MFN 10-189, Revision 2

Docket No. 52-010

Subject: **Revised Response (Revision 2) to Audit Open Items from the Summary of the June 3 and 15, 2010 NRC Regulatory Audits of the ESBWR Spent Fuel Pool Required Water Inventory**

Revised Response (Revision 2) to Audit Open Items from the Summary of the June 3 and 15, 2010 NRC Regulatory Audits of the ESBWR Spent Fuel Pool Required Water Inventory

Figure 1, Decay Power-Versus-Time Comparison

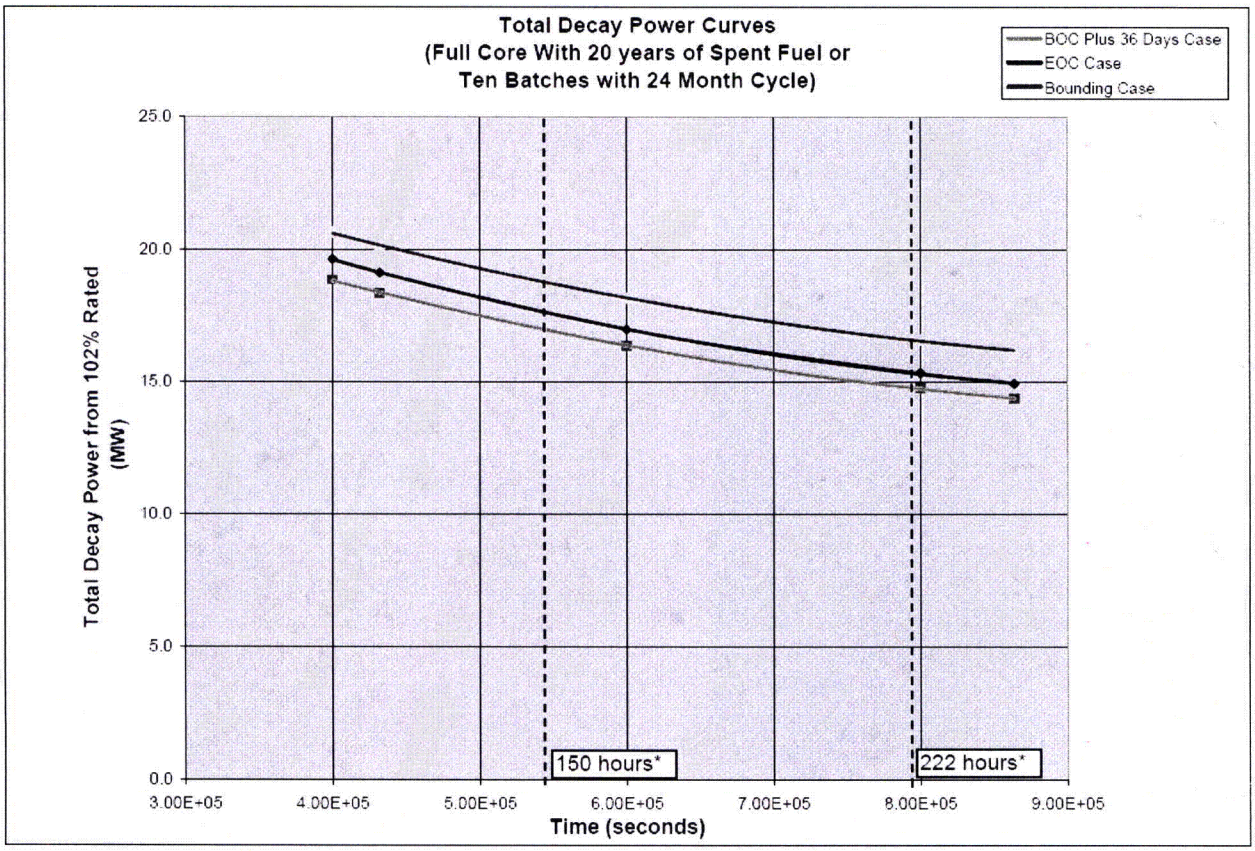
After the first revised response (MFN 10-189, Revision 1), a more conservative minimum required makeup rate was calculated using the same bounding decay power versus time input referred to in the preceding paragraph. This revised makeup rate has been incorporated into the audit item 5 response along with some rewrite for clarity. In addition, the NRC Staff has requested that GEH address any deviations from SRP section 9.1.3 in the areas of calculating decay energy and any assumptions used for determination of the most bounding heat load conditions. As with revision 1, this revised response retains the original content but appends each affected section with revised values or textual content, where applicable. All discussion related to variances from SRP section 9.1.3 is contained in the following two paragraphs.

*Boil-off volume calculated starting with power of full core after 150 hours decay per SRP 9.1.3, revision 1, and continuing for 72 hours.
